2.2.8 AMENDMENT 21: CPH

Reconfiguration of Scissor Stair 05/06
(to levels 00, 00 Mezz, 01, 01 Mezz & 02)

APPROVED PLAN
Drawing: 19402-CPA Ground Floor Plan

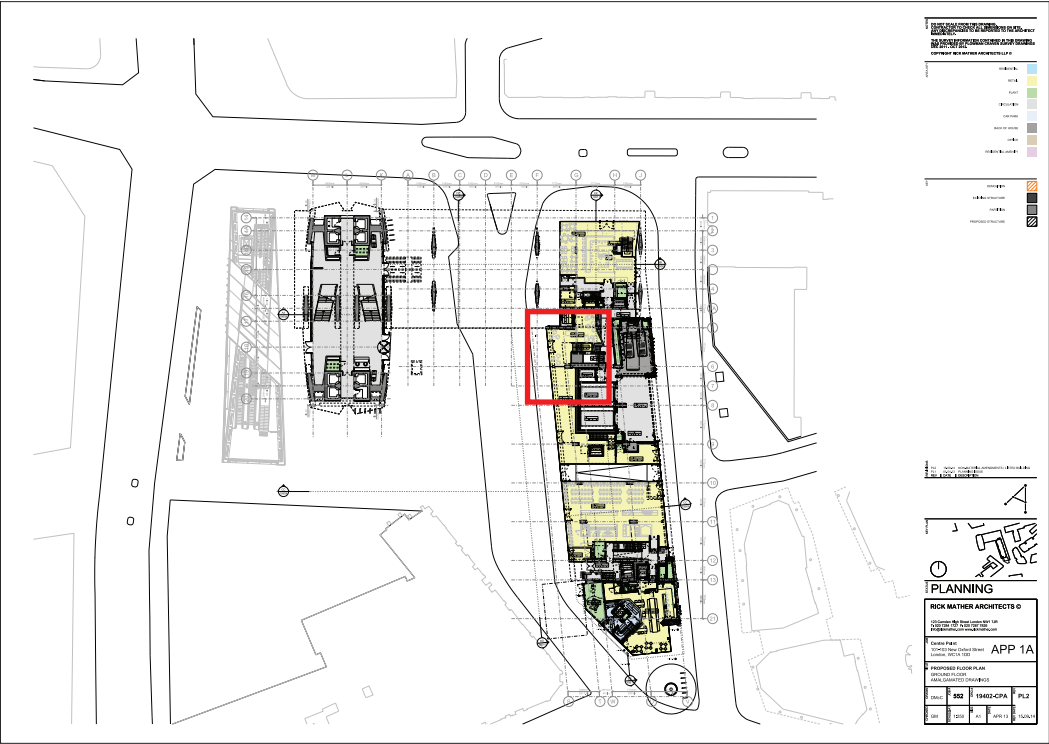
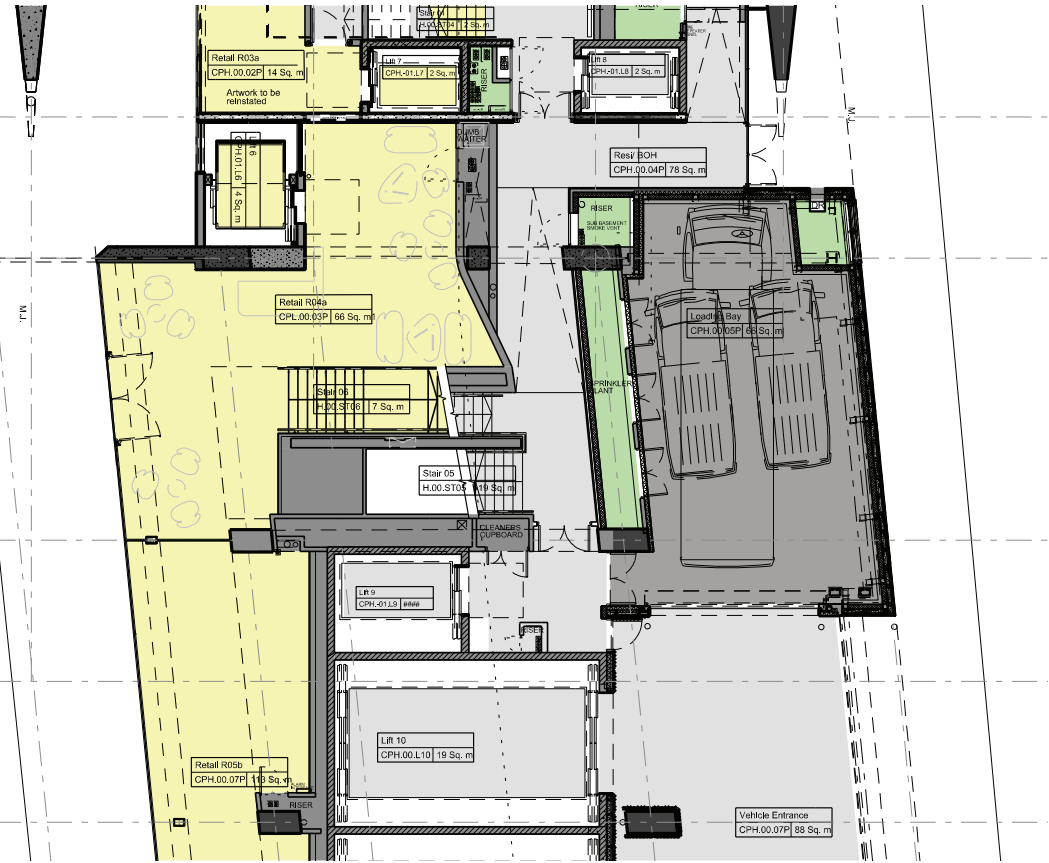
As part of the rationalisation exercise related to lift 06 the opportunity to rationalise the adjoining circulation areas was available. In particular, this meant it was possible to open up the void and reconfigure the form of the scissor stair 05 & 06. This ensured a simpler, sculptural form, providing a greater sense of void at the entrance and maximise the visual connection both across the void and between the retail units from the various floor levels and from the stair itself.

In addition, this meant there was an opportunity to reorganise the floor slab at level 01 and introduce a link bridge to form a new, more dramatic approach to retail unit R04.

We believe the changes both enhance the sculptural drama of the entrance void and increase the strong visual connections.
